SERVICE NOTE

model 175A OSCILLOSCOPE Serial Prefixes Below 436-

INCREASED VERTICAL DC STABILITY

Figure 1. HP Model 175A Oscilloscope, Schematic of Modified Circuit

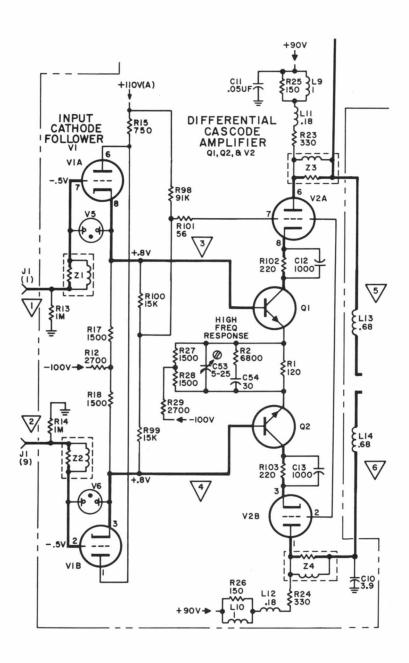
The DC stability of the main vertical amplifier in the above instruments may be improved by installing the Part No. 175A-65V input amplifier circuit board. This modification eliminates the small amount of trace drift that occurs over a period of one or two minutes after a DC voltage step is applied to the vertical input. This is the only advantage of the new board so the modification is worthwhile only if the slight drift poses a problem.

- 1. Remove top cover.
- 2. Replace Vertical Input Assembly A1 with new 175A-65V board. All connections remain the same.
- 3. Replace R46 on circuit board A2 with 1K ohms resistor.

Recalibrate the vertical amplifier as described in the Model 175A Operating and Service Manual except for the Adjustment Procedure change as follows: In the Hi Freq Response step of the Pulse Response Adjustment paragraph in the Maintenance Section of your Operating and Service Manual, substitute C53 for L7 and L8.

Ckt Ref	Description	@ Part No.
CHANGE:	TO:	
A1	Assy: vertical input	175A-65V
L13	Coil: fxd, rf, .68 μ h	9140-0094
R15	R: fxd, metal oxide, 750 ohms, 2%, 2W	0763-0009
R23, R24	R: fxd, comp, 330 ohms, 5% , $1/4W$	0683-3315
DELETE:		
C7, C8	C: fxd, cer, 0.05 μ f, 20% 400VDCW	0150-0052
L7, L8	Coil: var, rf	175A-60F
R16	R: fxd, comp, 1.5K, 1%, 1/2W	0727-0110
R19, R20	R: fxd, comp, 68 ohms, 5%, 1/4W	0683-6805
R21, R22	R: fxd, metal film, 6.5K, 5%, 3W	0767-0006

* ADD:		
C12, C13	C: fxd, cer, 1000 pf, 600VDCW	0150-0050
C53	C: var, cer, 5-25 pf	0130-0016
C54	C: fxd, mica, 30 pf, 5%, 500VDCW	0140-0203
Q1, Q2	Transistor: 2N708	1854-0005
R1	R: fxd, comp, 120 ohms, 10% , $1/4$ W	0684-1211
R2	R: fxd, comp, 6.8K, 5%, 1/4W	0683-6825
R27, R28	R: fxd, comp, 1.5K, 10%, 1/2W	0687-1521
R29	R: fxd, comp, 2.7K, 5%, 3W	0767-0021
R98	R: fxd, comp, 91K, 5%, 1/2W	0686-9135
R99, R100	R: fxd, comp, 15K, 5%, 1/4W	0684-1535
R101	R: fxd, comp, 56 ohms, 10%, 1/4W	0684-5601
R102, R103	R: fxd, comp, 220 ohms, 10% , $1/4$ W	0684-2211

* Refer to Figure 1.
